**BEFORE THE IDAHO PUBLIC UTILITIES COMMISSION**

<b>IN THE MATTER OF IDAHO POWER</b>	)	
<b>COMPANY'S APPLICATION FOR</b>	)	<b>CASE NO. IPC-E-22-06</b>
<b>APPROVAL OF A REPLACEMENT SPECIAL</b>	)	
<b>CONTRACT WITH MICRON</b>	)	
<b>TECHNOLOGY, INC. AND A POWER</b>	)	<b>COMMENTS OF THE</b>
<b>PURCHASE AGREEMENT WITH BLACK</b>	)	<b>COMMISSION STAFF</b>
<b><u>MESA ENERGY, LLC</u></b>	)

**STAFF OF** the Idaho Public Utilities Commission, by and through its Attorney of record, Riley Newton, Deputy Attorney General, submits the following comments.

*Diagram A: Staff’s Ideal Framework*

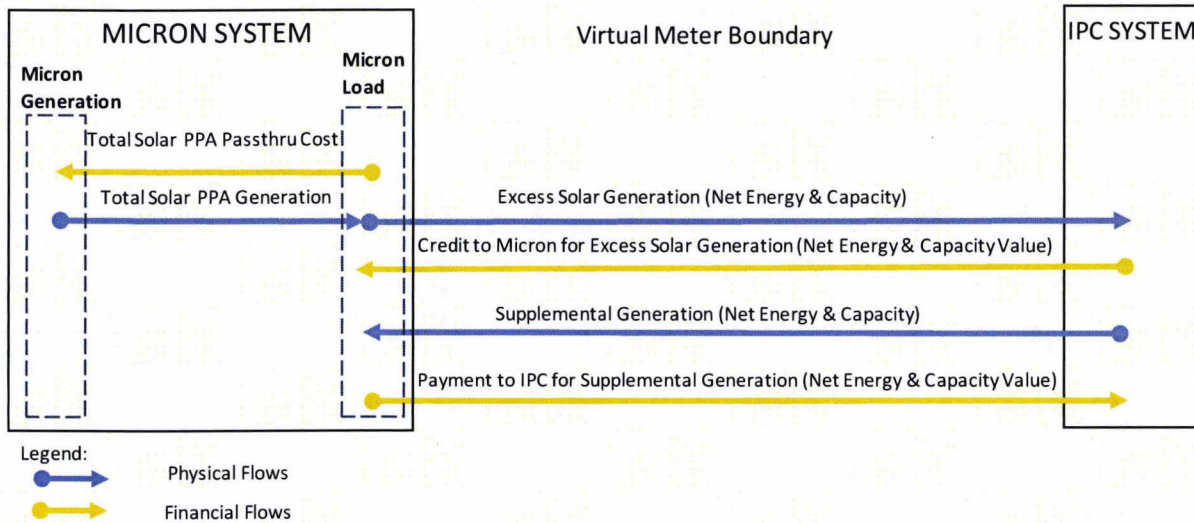
As depicted in Diagram A, the Company’s proposed rate design can be analyzed based on a “virtual behind the meter” framework, as if Micron’s resource is generating into its own load.

This framework is appropriate for two reasons. First, the structure of the Special Contract requires 100% of the renewable PPA costs to be passed through to Micron before credits for Excess Generation and charges for Supplemental Generation are applied. This is

similar to other large customers that own generation capability and generate into their own load,<sup>2</sup> whereby the resources selected will likely be based on Micron's preferences and dedicated for its benefit. These resources may not necessarily be selected as a least cost resource for the benefit of all customers. Second, although the renewable resource(s) the Company will procure for Micron will connect directly to the Company's system separate from the Micron's load, Micron's consumption and the production from its renewable resource(s) will be netted mathematically on an hourly basis using metered data.

Utilizing a "virtual behind the meter" framework for Staff's analysis is ideal because: (1) Supplemental Generation (consumption net of generation) can be analyzed to ensure that the rates charged for electricity delivered to Micron from the Company's system should be based on principles of cost of service ("COS"); and (2) Excess Solar Generation (production net of consumption) exported to the Company's system from Micron should be analyzed based on principles of avoided cost.
